# ADVISORY WIRE

REFERENCE NO:	AW300-24-0222	INFORMATION TYPE:	Maintenance Operational
ATA:	24	EFFECTIVITY:	Challenger 300 (20003 to 20500) Challenger 350 (20501 to 20635)
<b>SUBJECT:</b>	<b>Aft Fuselage - APU Generator Power Feeder Cable Fouling Condition</b>

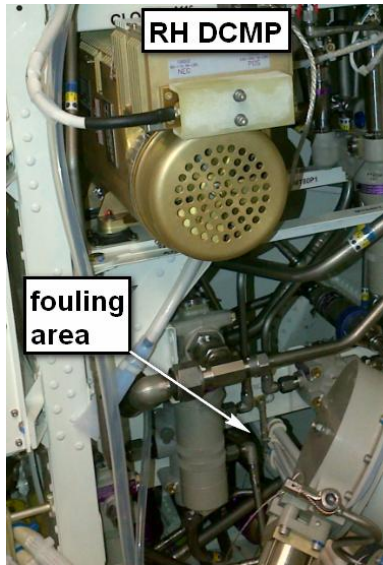
An APU generator power feeder cable was found touching the Ref. 1.1 hydraulic system return line, under the right hydraulic equipment rack, during a scheduled maintenance inspection in the aft equipment compartment of a Challenger 300. See photos on page 2.

Close up view of fouling area

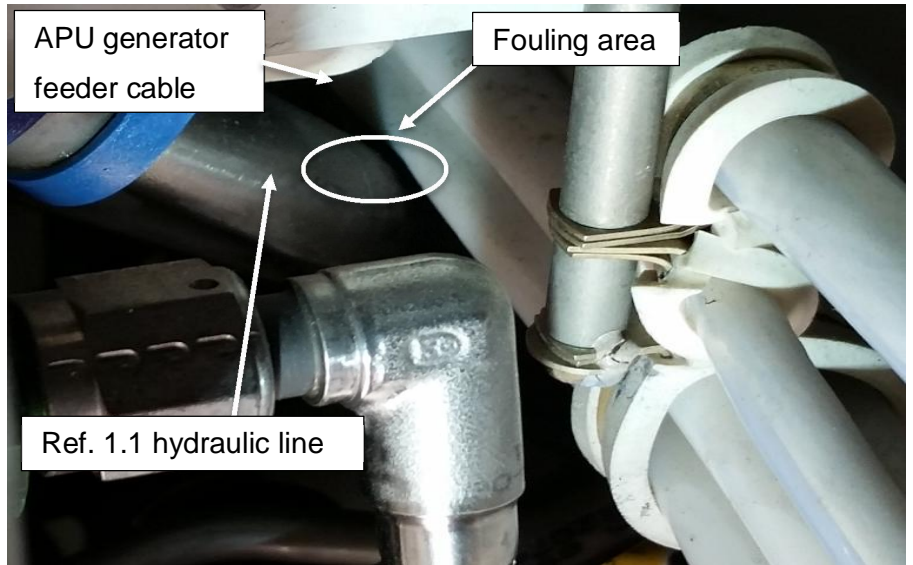
There was no effect reported on the aircraft systems and only some minor damage was found on the insulation jacket of one of the two APU generator power feeder cables (photos next page). Neither the hydraulic line, nor the power feeder wire had to be replaced. The power feeder wires were pushed away slightly from the Ref. 1.1 hydraulic line to re-establish a proper clearance (minimum of 0.5") and the aircraft was returned to service.

Service bulletins for the Challenger 300 and 350 models will be released shortly to address this fouling condition. The rework will consist of removing the existing power feeder cables supporting hardware (multiple clamps configuration) and replacing it with the one clamp supporting hardware configuration currently installed onto aircraft 20636 and subs.
